Ford Motor Company

Design Change

China CDX707 DAT Subscription SYNC+ IVI Enrollment and Unenrollment

Version 1.1

Unenrolled – APA

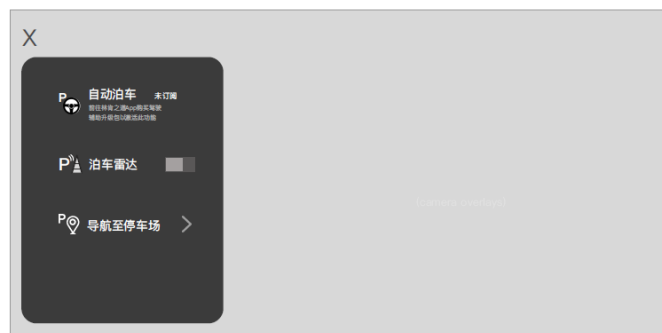
3.5.2. APA

3.5.2.1. Remove “自动泊车” switch

3.5.2.2. Do not display any alert information under APA button

3.5.2.3. Add text

“ 已取消订阅

前往林肯之道App购买驾驶辅助升级包以激活此功能”
